TO: James L. App, City Manager
FROM: Ronald Whisenand, Community Development Director
SUBJECT: Chandler Ranch Area Specific Plan Revisions
DATE: August 31, 2010

Subject: 2010 Concept Plan and Design Refinements in Response to Chandler Ranch Specific Plan (CRASP) Peer Review Report -- October 29, 2007; Request for meeting with City Council Ad-Hoc Committee to review the CRASP Update

29 OCTOBER 2007

Prepared by:
Moule & Polyzoides Architects and Urbanists

CHANDLER RANCH 2010 CONCEPT PLAN

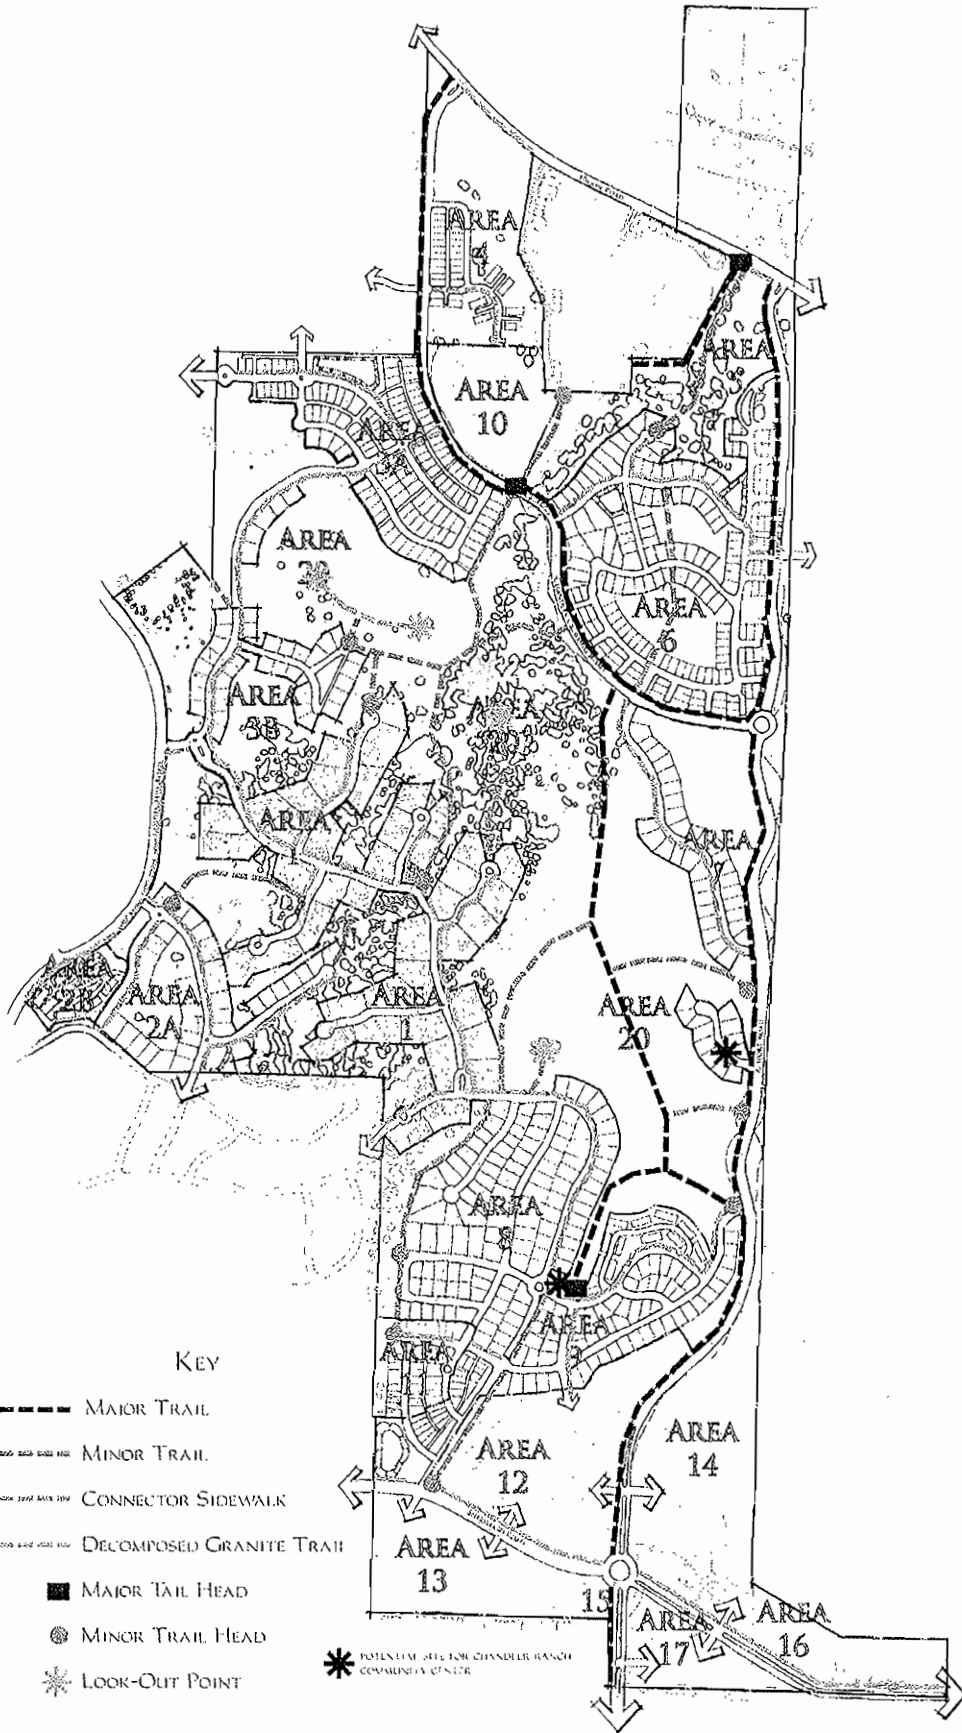
Area 2A: Remove the three lots and cul-de-sac that cause potential uphill grading.

Area 3A: Add access to commercial property to the north from Gilead Lane

Area 4: Add access to the commercial property to the west, across Chandler Crossing Road.

Area 6: Eliminate cul-de-sac and add through connection to Airport Road in the north.

Add Perpendicular Lotting Concept (PLC) units along Airport Road, eliminating traditional single family. The intent is to remove rear exposure to street, replacing it with side exposure.

Area 7: This area is the "flex" area. The number and type of units will be finalized here after the other planning areas are refined. This concept shows a limited number of semi-custom home sites – a relatively sensitive grading scheme.

Chandler Ranch Specific Plan Areas 4, 5, 6, 7A, and 7B.

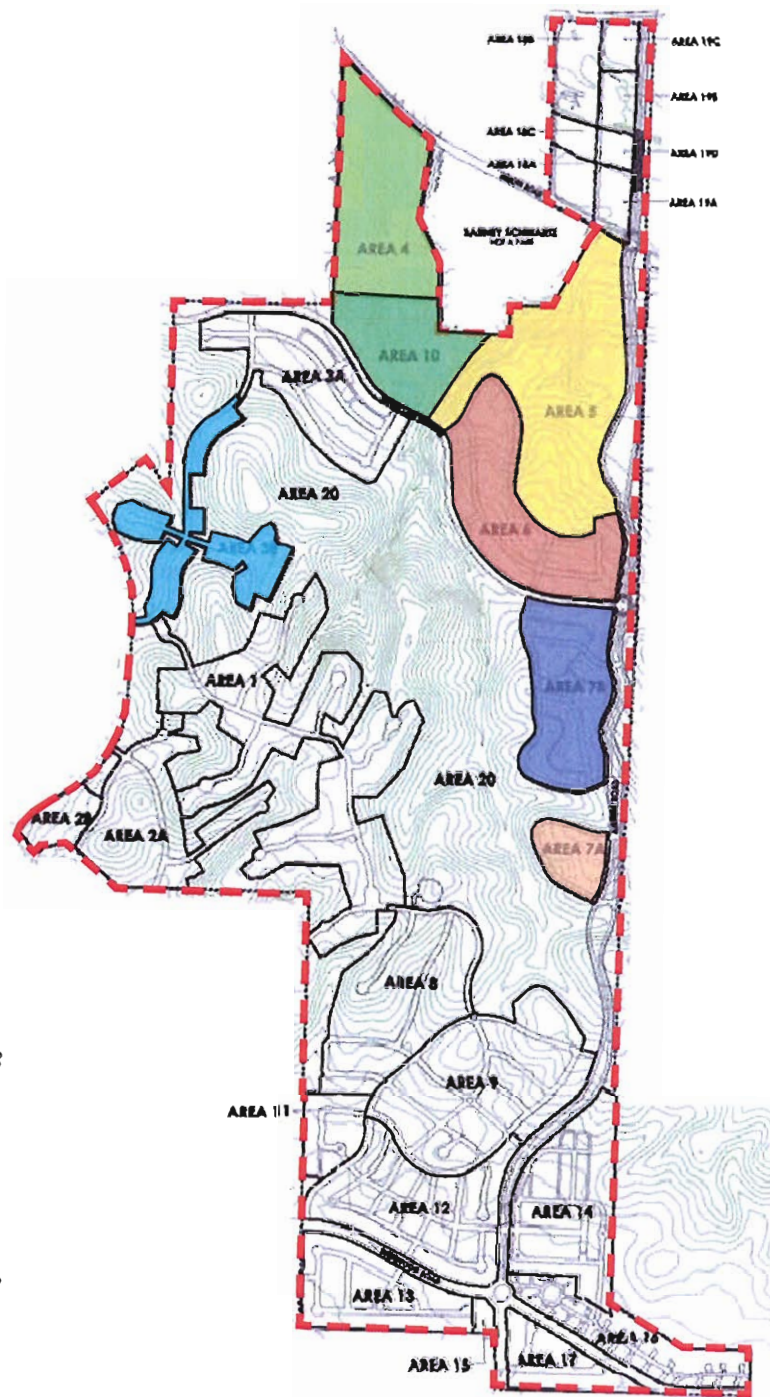
Area 7A is currently a single generally round block. The current housing density diagram indicates that higher densities are planned for that area. While it is possible to design buildings containing denser housing that would look appropriate sitting in a little block that is surrounded by natural open space and vineyards, the chances of a merchant builder doing so are negligible. We strongly recommend that this area be planned for single-family detached homes that substantially preserve the existing contours of

The layout shown for 7B is quite good, providing lots that front Gilead and Airport on the north and east edges, as well as the roads adjoining the open space along the west and south edges. The alleys that have been added provide vehicular access to the lots, providing a great deal of flexibility in lot widths, and allowing the front yards to be beautifully landscaped and free of automobile parking.

The internal street in the southerly portion of this area comes very close to Airport Road causing some undesirable results. The lots in the southwest portion of the area are very deep, whereas the lots in the southeast portion, facing Airport Road are very shallow, and either back up to Airport Road or to the internal street, neither of which is a good option. If that internal street were shifted to the west, there could be an entire block to the east of it, such that lots fronting Airport Road and fronting the internal street would be possible. That block should contain an alley to avoid driveways onto Airport Road.

All of the neighborhood edge streets must have curbside parking for visitors. On Airport Road, and on the road along the west and south edges, parking could be accommodated on a wide shoulder composed of pervious pavement (such as pervious concrete, pervious pavers, or other permeable surfaces that are approved by the Planning Director). On Airport Road, parking could also be accommodated along a frontage lane that would also facilitate access to homes facing Airport Road. This second alternative is probably the better solution for carrying relatively heavy traffic loads and at the same time allowing buildings and street parking to front on the narrower, quieter, and separate frontage lanes. Both configurations could be lined with informally planted oak trees that emphasize the rural character of the streets.

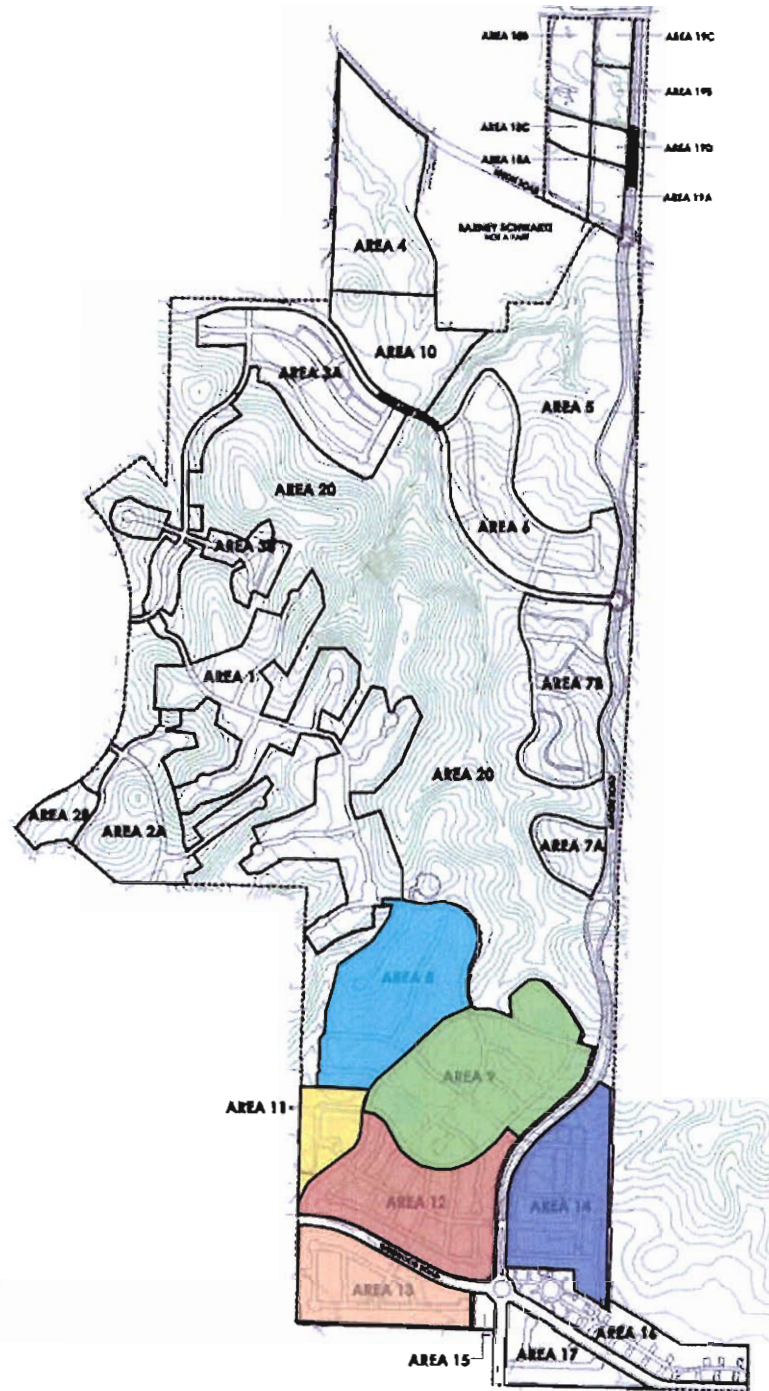
Perhaps the greatest improvement to the master plan to date has been the unification of the plan for Areas 8, 9, 11, 12 and 14. In the July 30 meeting the possibility of reorienting lots around the edges of Areas 9 and 12 so that they front the perimeter streets rather than backing to them was discussed, as was the possibility of more unified planning as regards areas 13, 15, 16 and 17.

Accordingly we provide some comments regarding these areas as a group. We still have significant concerns about the details of the layouts for these areas, but the clear conceptual intention is that they be joined together into a single neighborhood of interconnecting streets and reasonably scaled blocks. Specific concerns about this layout include:

- b. The block sizes in Area 12 are very small and it appears that some of the blocks must be only one lot deep. In the July 30 meeting the possibility that some of the streets are actually alleys was discussed. This area should be redrawn, including some illustrative lotting, so that the difference between streets and alleys is clear, and hence the fronts and backs of lots are clear. In blocks where larger lots are planned, alleys are completely optional, but if lots less than 60 feet wide are contemplated, provision should be made for alleys. Also the lots abutting Sherwood Road and Airport Road should have alleys, so that driveways do not connect to Airport Road or Sherwood Road. Elsewhere, the decision to include an alley or not can certainly be made when the tentative map is prepared and the lot sizes and building types are known.

rural avenues it is completely inappropriate. And to have this condition across the street from the fronts of residences and/or small commercial establishments in Area 12 and the Olsen Neighborhood would be doubly damaging. The layouts of these areas need to be redesigned to correct this.

This area appears to heading toward a neighborhood center character, and we recommend further clarifying that intention. We also recommend that buildings front Sherwood, with and/or without a frontage road, and that serious consideration be given to locating non-residential uses along the Sherwood frontage.
